Project	IEEE 802.16 Broadband Wireless Access Working Group < http://ieee802.org/16 >	
Title	Inheritance Relationship of 802.16 Mobility MIB	
Date Submitted	2006-03-01	
Source(s)	Yanbiao Chen	xu.ling@zte.com.cn
	Ling Xu	
	ZTE corporation	
	Daning Guo	gongdaning@catr.com.cn
	CATR	
Re:	Contribution to IEEE 802.16i	
Abstract	In this contribution, we propose to provide inheritance relationship of 802.16 mobility MIB	
Purpose	Adoption	
Notice	This document has been prepared to assist IEEE 802.16. It is offered as a basis for discussion and is not binding on the contributing individual(s) or organization(s). The material in this document is subject to change in form and content after further study. The contributor(s) reserve(s) the right to add, amend or withdraw material contained herein.	
Release	The contributor grants a free, irrevocable license to the IEEE to incorporate text contained in this contribution, and any modifications thereof, in the creation of an IEEE Standards publication; to copyright in the IEEE's name any IEEE Standards publication even though it may include portions of this contribution; and at the IEEE's sole discretion to permit others to reproduce in whole or in

Figure 13 IEEE802.16 NRM PacketCS Inheritance Diagram

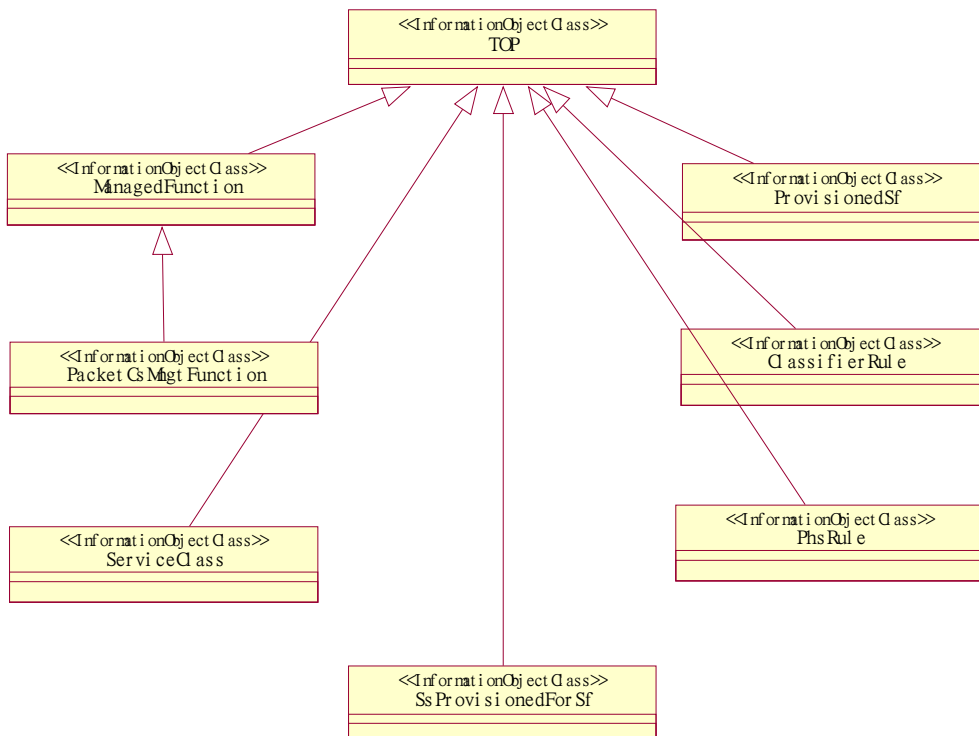
[Add the following description into 16i 15.1.2.2.2:]

The PacketCS IOC inheritance hierarchy:

Figure 14 IEEE802.16 NRM CPS Inheritance Diagram

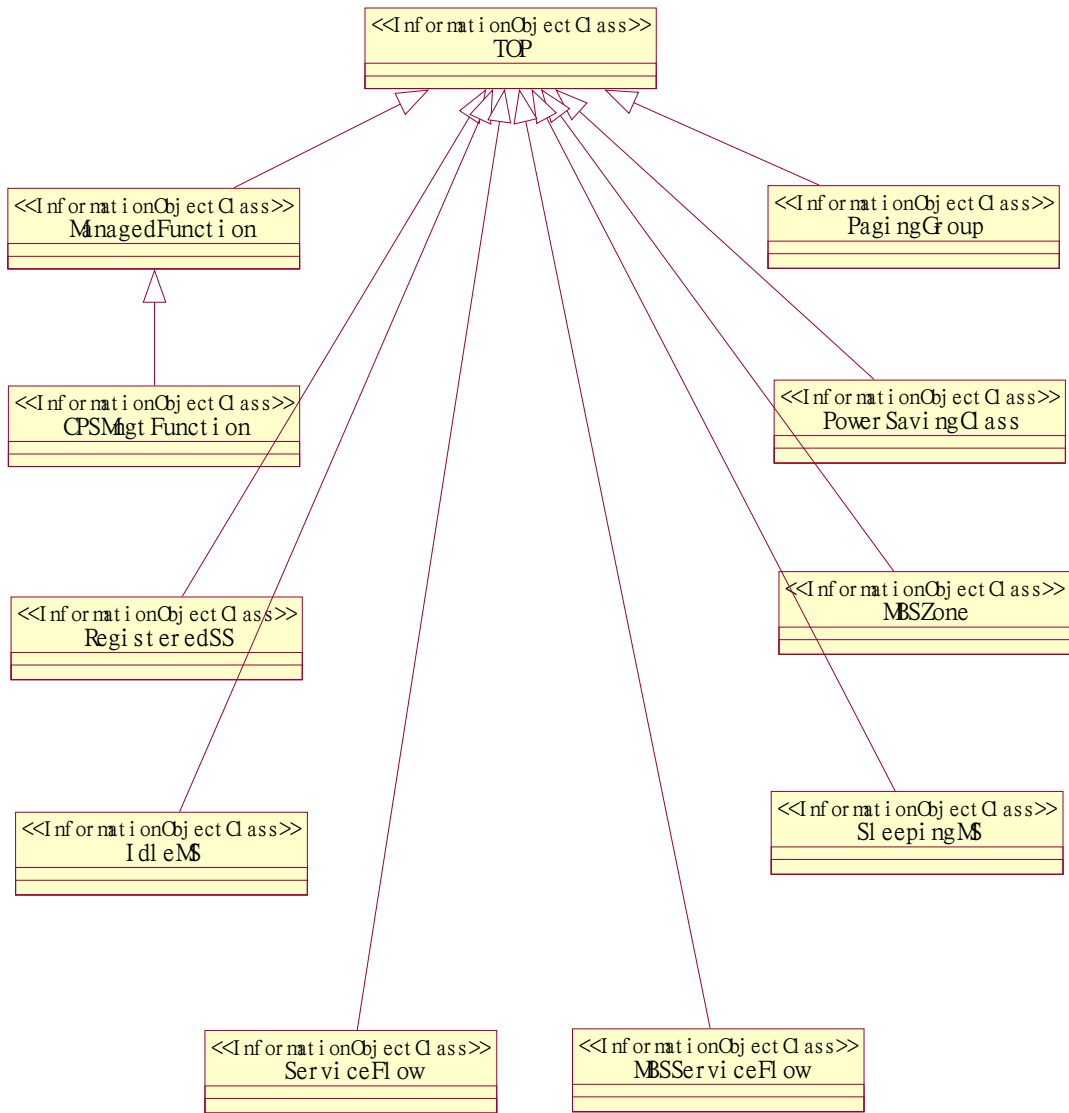
The CPS IOC inheritance hierarchy:

Figure 15 IEEE802.16 NRM Security Sublayer Inheritance Diagram

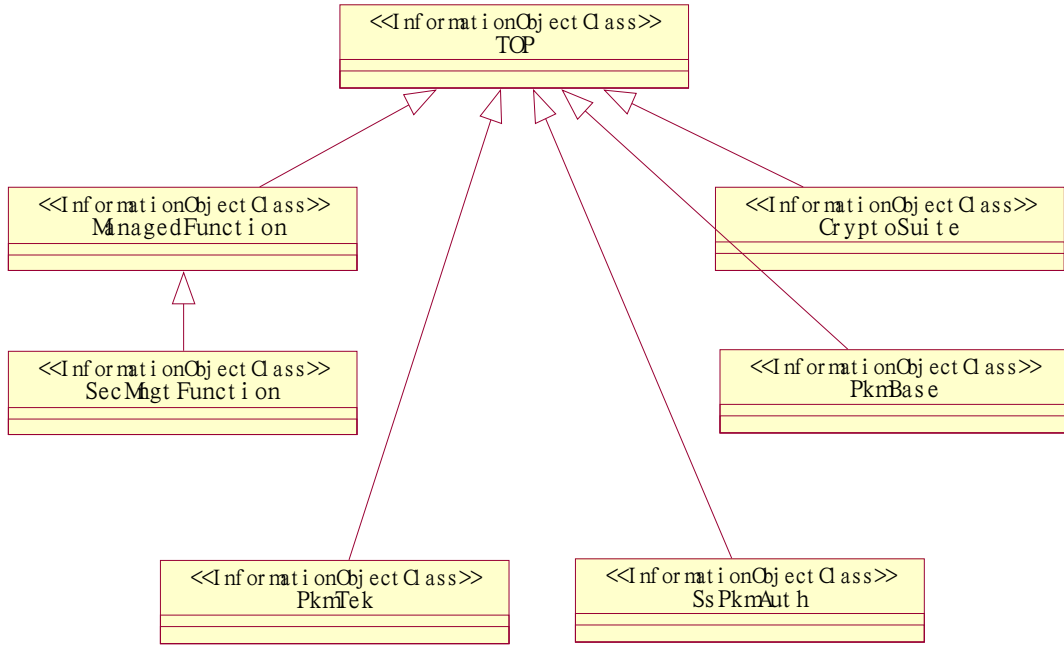
The Security sublayer IOC inheritance hierarchy:

Figure 16 IEEE802.16 NRM PHY Layer Inheritance Diagram

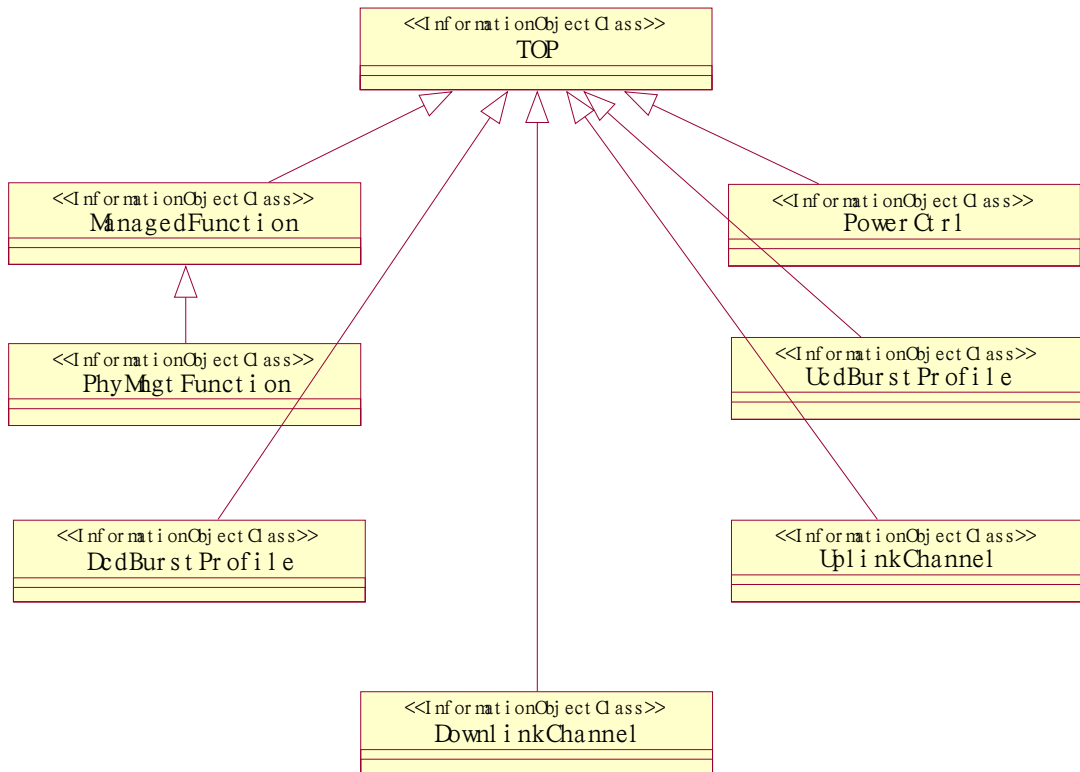
The PHY layer IOC inheritance hierarchy:
